Town of Franklin

Planning Board

September 28, 2020

DATE: September 23, 2020
TO: Franklin Planning Board
FROM: Department of Planning and Community Development
RE: Lakeview Terrace – Private Subdivision
Partial Form H

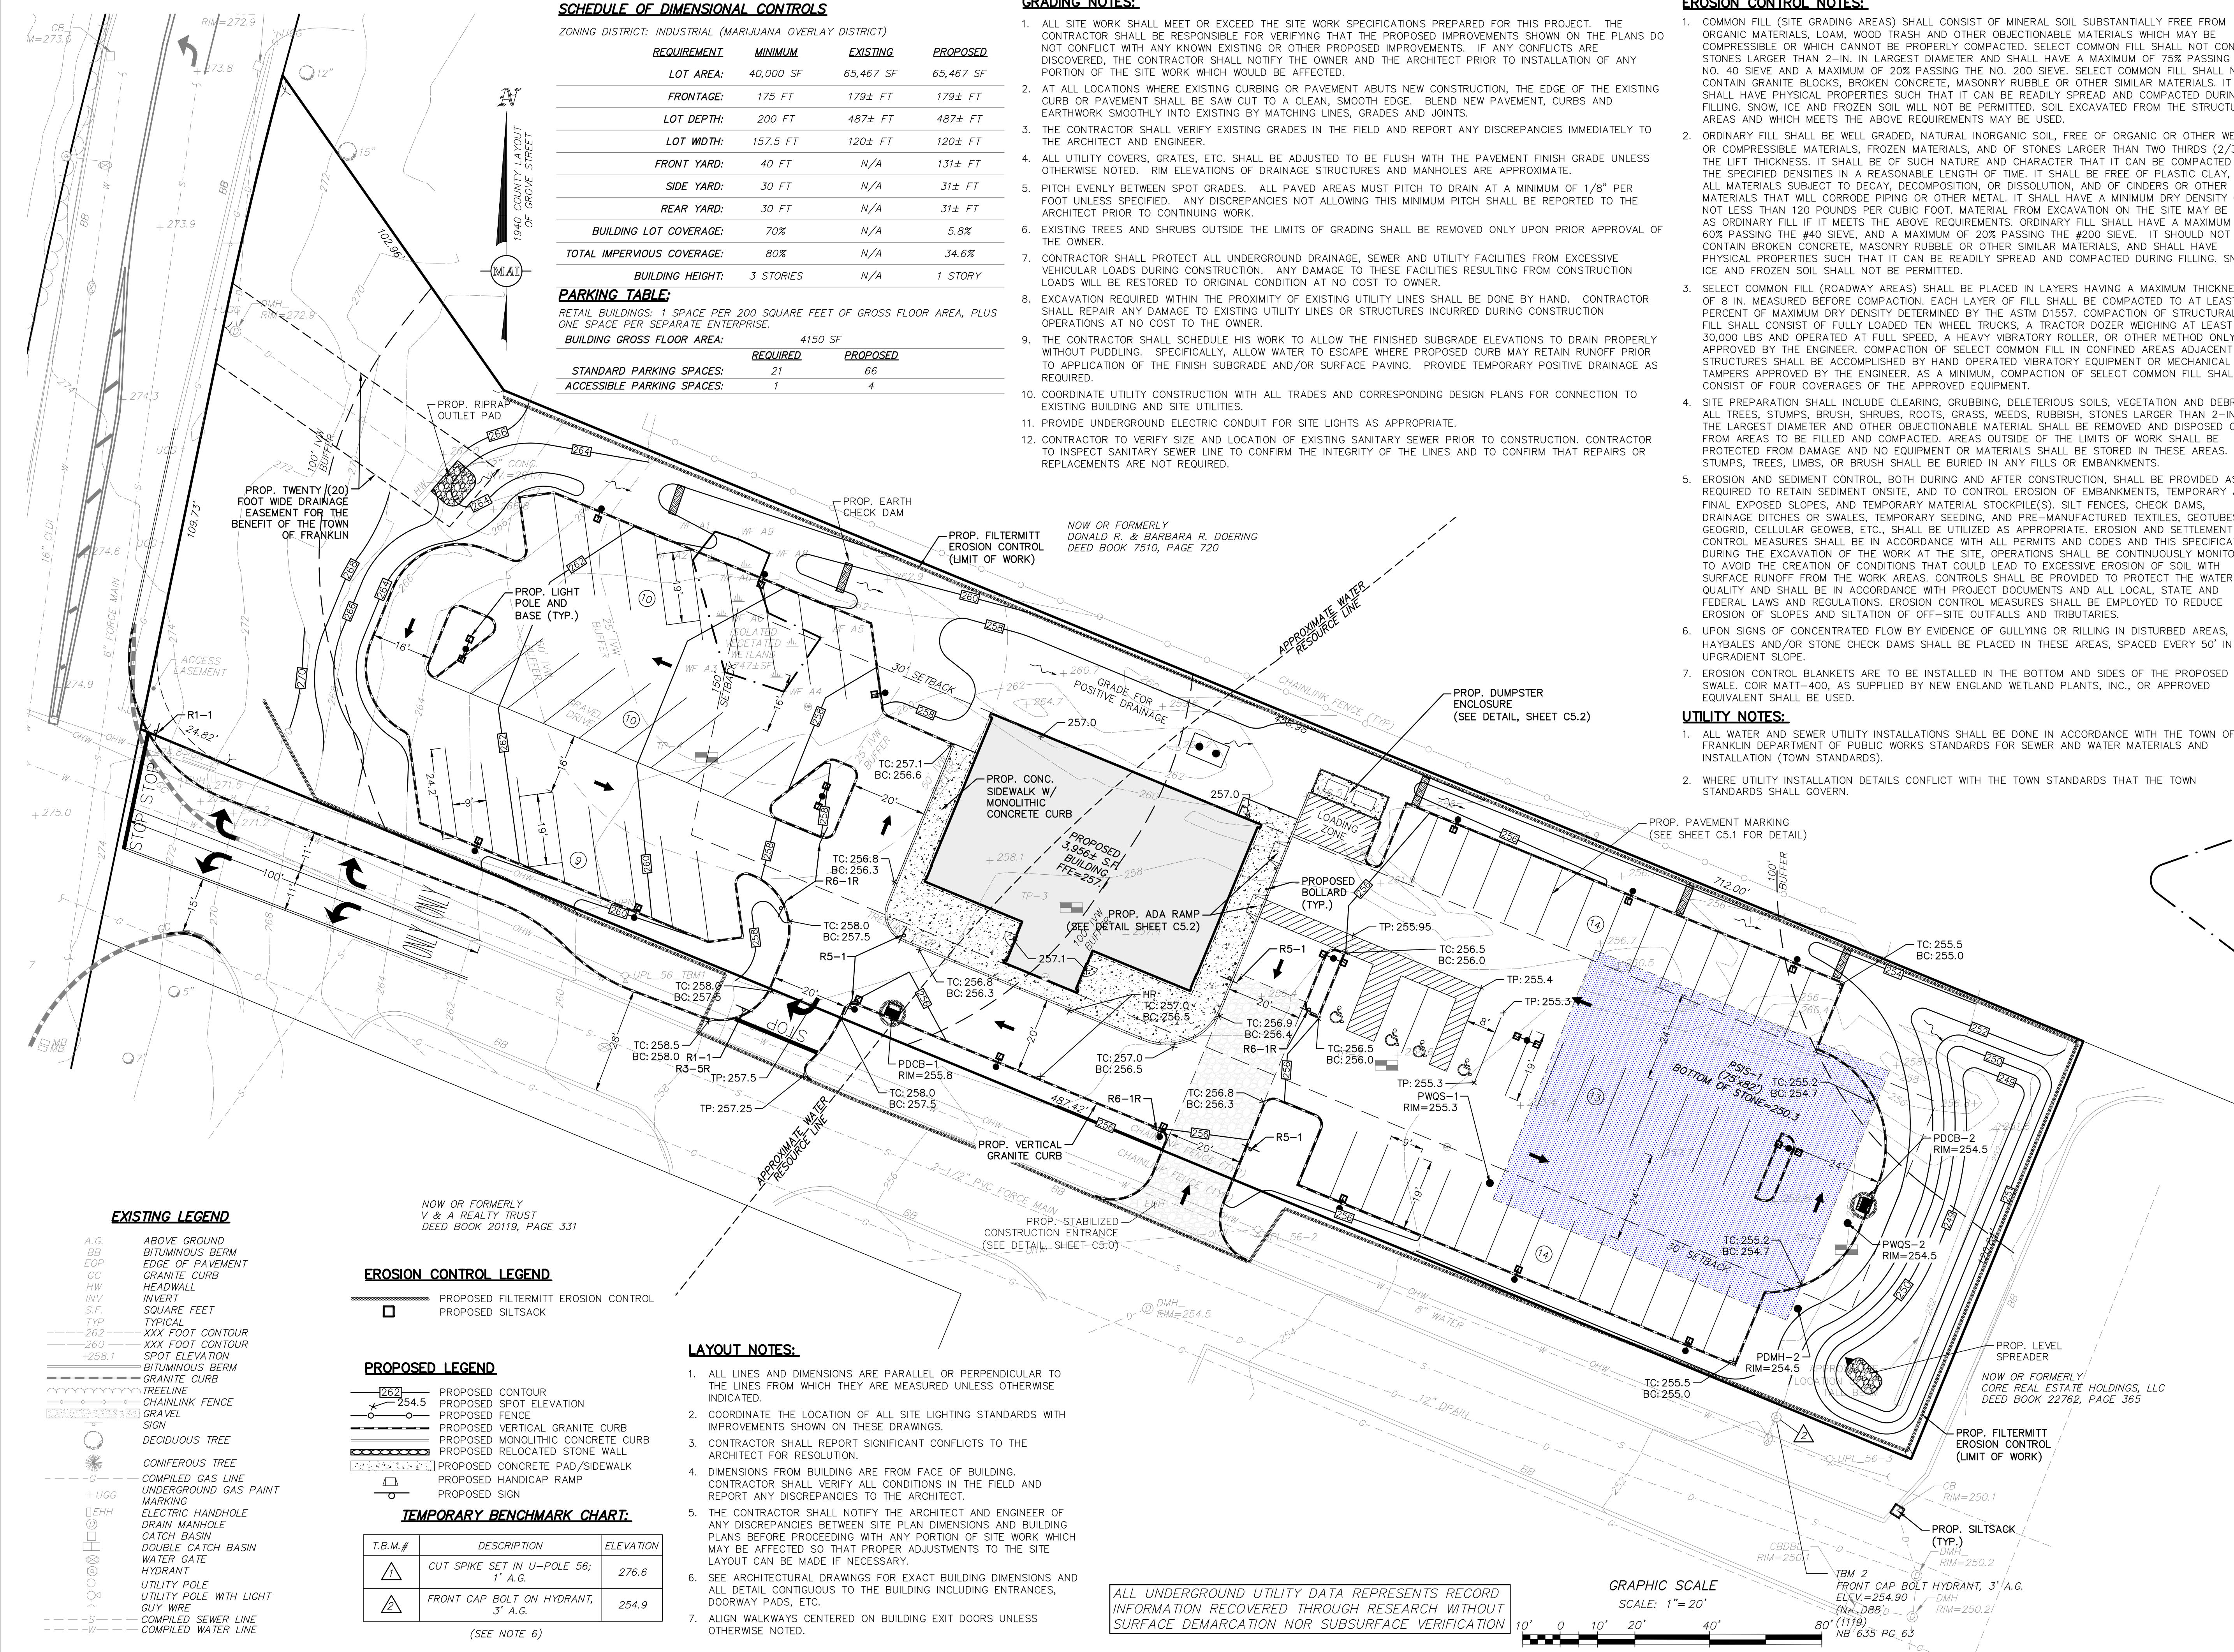
- P1. The angled parking layout conforms to industry standards; however, the usable stall length is only 18 feet. Revise the usable stall length to be 19 feet §185-21.C.(9)(a). *MAI: The length of the angled parking spaces has been revised accordingly, refer to Sheet C 2.0.* BETA2: Stall length revised – issue resolved.

- S11. Clarify limits of vertical granite curb as it relates to the concrete walkway. The Concrete Walkway Detail depicts monolithic concrete curb. *MAI: The limits of the types of curbing have been clarified, refer to Sheet C 2.0.* BETA2: Clarification provided – issue resolved.

- S3. Depict proposed limits of clearing on the plans, as applicable, including areas of existing vegetation to be retained (§185-31.C.(3)(u)). *MAI: The limit of clearing / limit of work is shown on the Site Plan, refer to Sheet C 2.0 of the plan set. It has also been added to Sheet C 1.0.* BETA2: Information provided – issue resolved.

SW4. In coordination with the Town, provide an easement for the existing outfall at the northwest end of the site. *MAI: An easement for the town at the headwall has been depicted graphically on the plan set, refer to Sheet C 2.0.* BETA2: Easement provided. BETA defers any additional comment to the DPW.

SW6. Consider providing periodic check dams in the northerly swale to minimize flow velocities and promote infiltration. *MAI: Check dams have been added to the plan set, refer to Sheet C 2.0.* BETA2: Check dams provided – issue resolved.

SW7. Clarify where the Typical Level Spreader is proposed. *MAI: The location of the level spreader has been added to the plan set, refer to Sheet 2.0.* BETA2: Clarification provided – issue resolved.

SW25. Provide perimeter controls along the southwestern border of the Site (e.g. where existing flows are directed to DP1). *MAI: Perimeter erosion controls have been added to the plan set, refer to Sheets C 1.0 and C 2.0.* BETA2: Perimeter controls provided – issue resolved.

- P1. The angled parking layout conforms to industry standards; however, the usable stall length is only 18 feet. Revise the usable stall length to be 19 feet §185-21.C.(9)(a). *MAI: The length of the angled parking spaces has been revised accordingly, refer to Sheet C 2.0. BETA2: Stall length revised – issue resolved.*

- S11. Clarify limits of vertical granite curb as it relates to the concrete walkway. The Concrete Walkway Detail depicts monolithic concrete curb. *MAI: The limits of the types of curbing have been clarified, refer to Sheet C 2.0.* **BETA2: Clarification provided – issue resolved.**

- S3. Depict proposed limits of clearing on the plans, as applicable, including areas of existing vegetation to be retained (§185-31.C.(3)(u)). *MAI: The limit of clearing / limit of work is shown on the Site Plan, refer to Sheet C 2.0 of the plan set. It has also been added to Sheet C 1.0.* **BETA2: Information provided – issue resolved.**

- SW4. In coordination with the Town, provide an easement for the existing outfall at the northwest end of the site. *MAI: An easement for the town at the headwall has been depicted graphically on the plan set, refer to Sheet C 2.0.* **BETA2: Easement provided. BETA defers any additional comment to the DPW.**

- SW8. Although the existing outfall at the northwest corner of the site is not the responsibility of the project proponent, it is recommended to provide a rip rap pad at the outlet. *MAI: A rip rap pad has been added to the existing outfall pipe, refer to Sheet C 2.0. BETA2: Rip rap pad provided – issue resolved.*

SW25. Provide perimeter controls along the southwestern border of the Site (e.g. where existing flows are directed to DP1). *MAI: Perimeter erosion controls have been added to the plan set, refer to Sheets C 1.0 and C 2.0. BETA2: Perimeter controls provided – issue resolved.*

C4.0

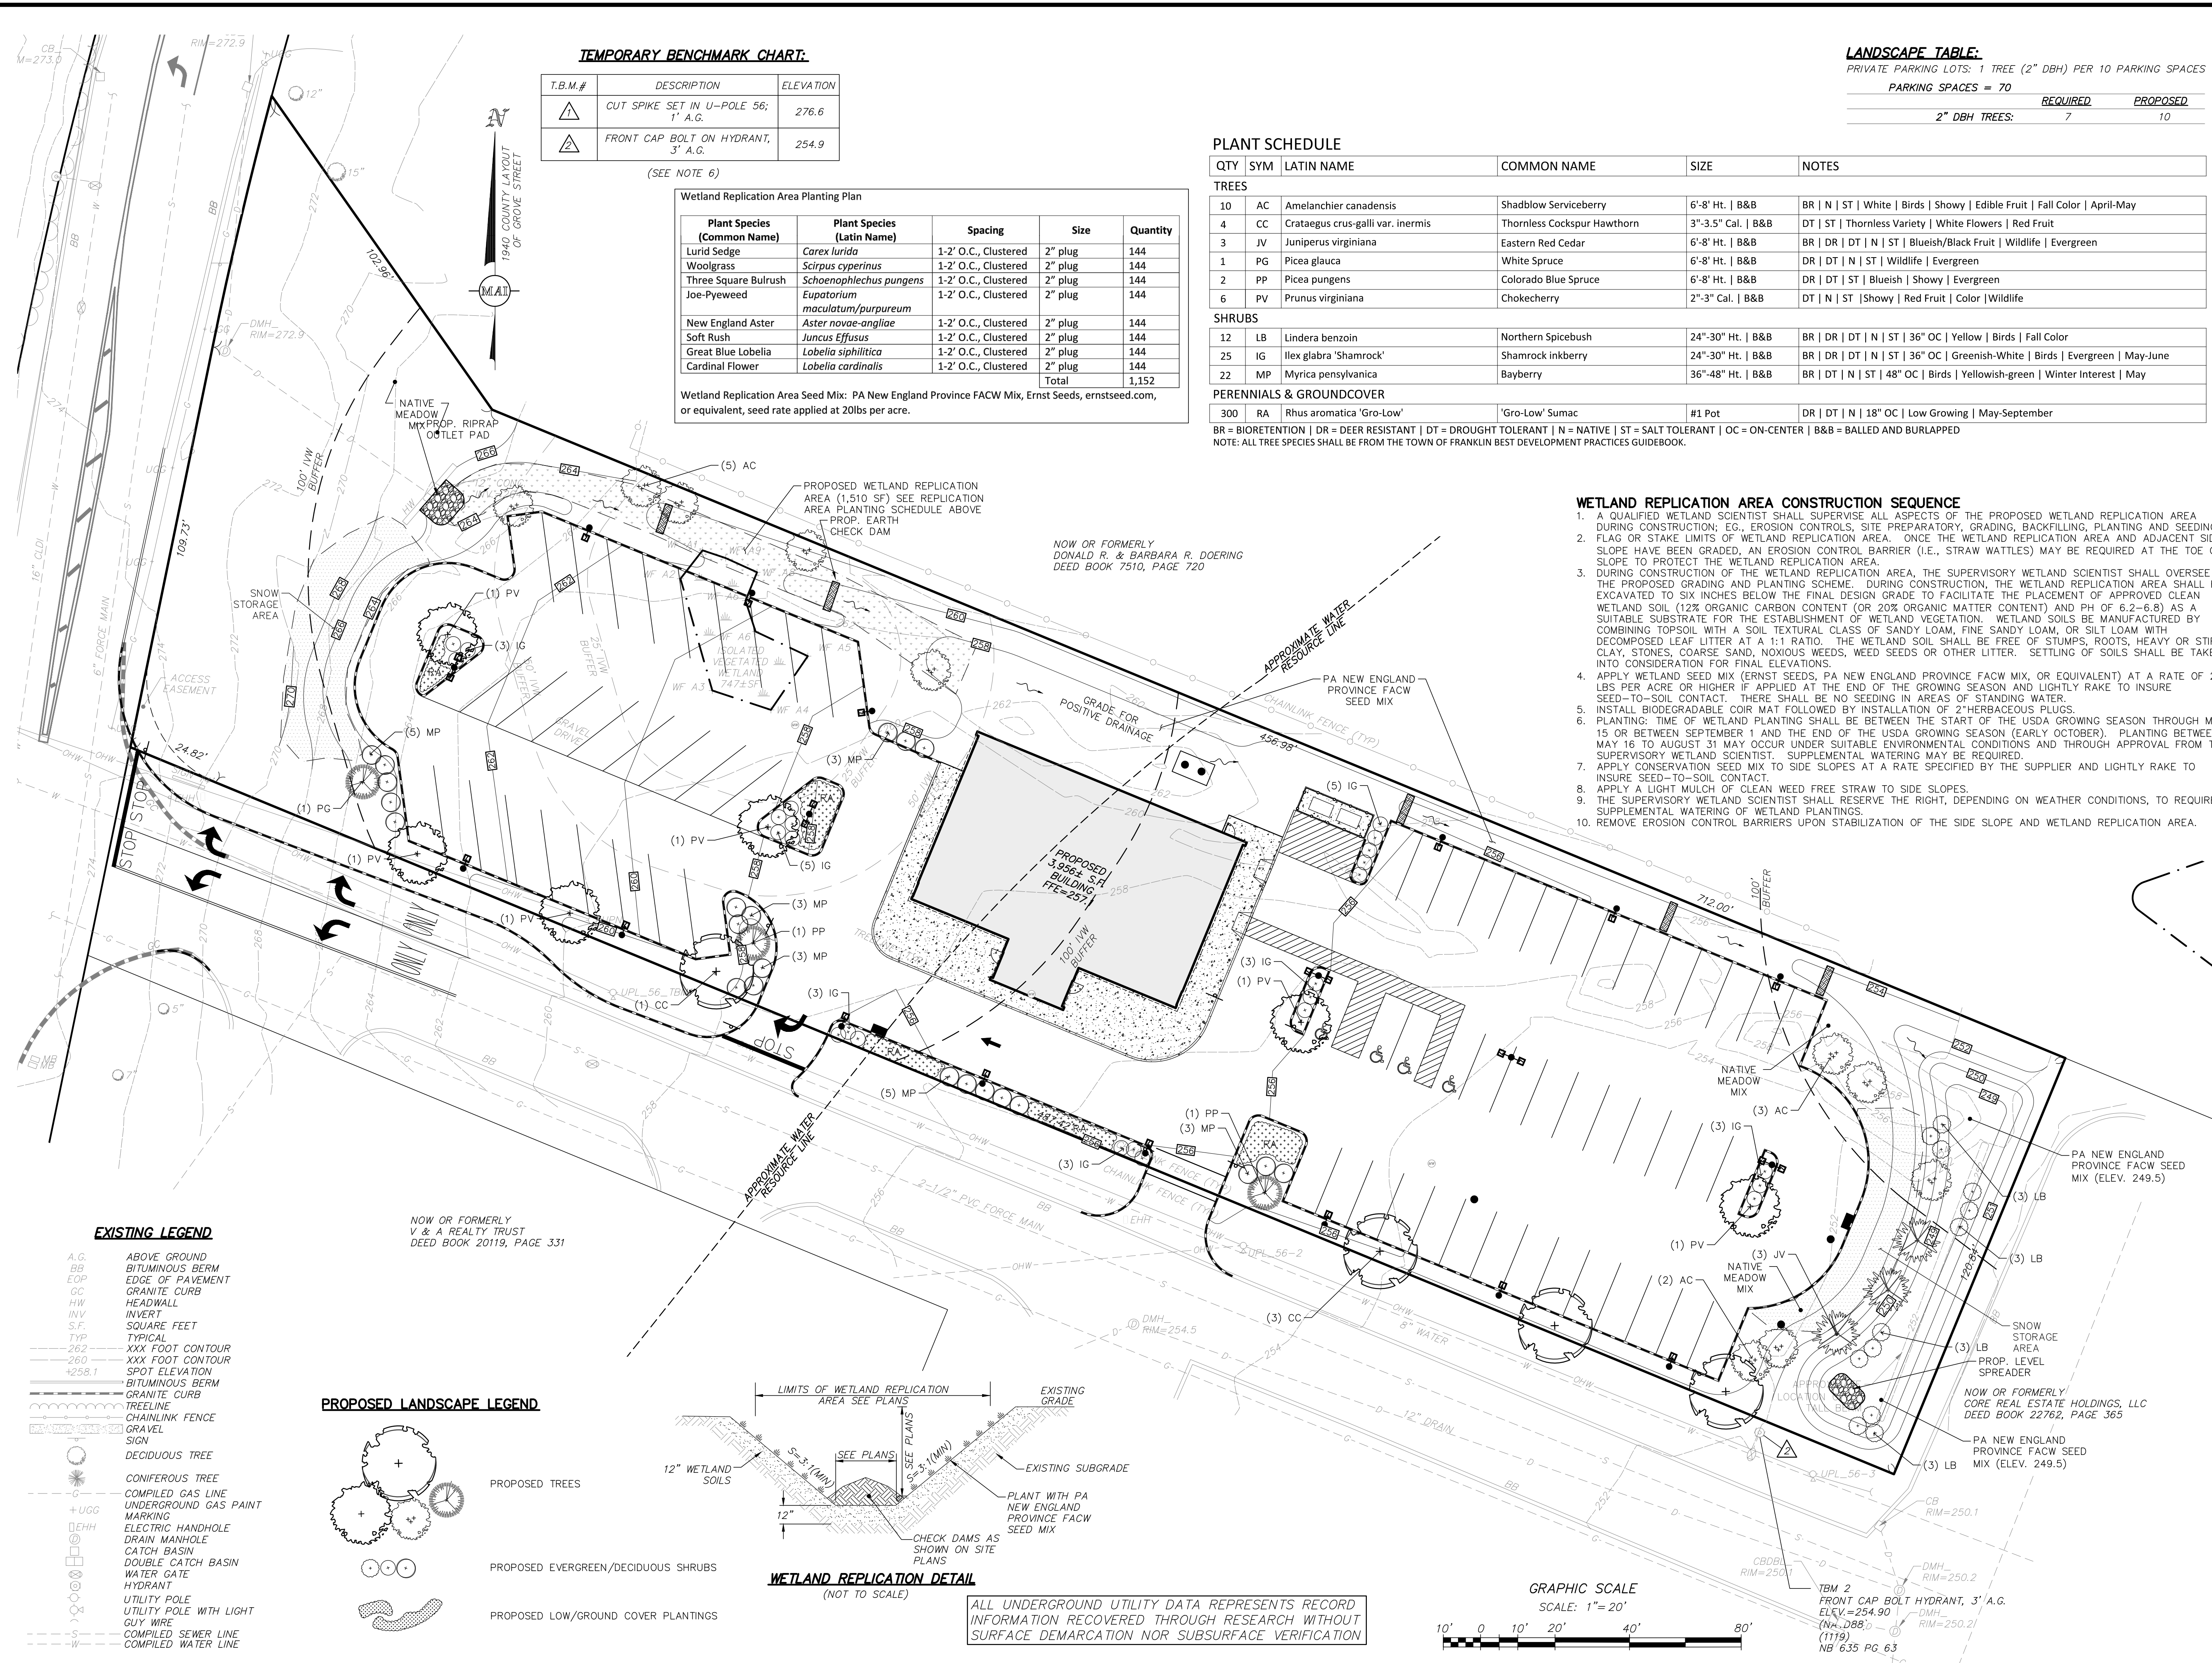
- G4. Recommend revising snow storage areas to maintain clear flow path within swale along the northerly property line. Consider providing additional snow storage along the southerly curb line. *MAI: The snow storage locations have been adjusted accordingly, refer to Sheet C 4.0.*
BETA2: Snow storage area revised – issue resolved.

- G4. Recommend revising snow storage areas to maintain clear flow path within swale along the northerly property line. Consider providing additional snow storage along the southerly curb line. *MAI: The snow storage locations have been adjusted accordingly, refer to Sheet C 4.0. BETA2: Snow storage area revised – issue resolved.*
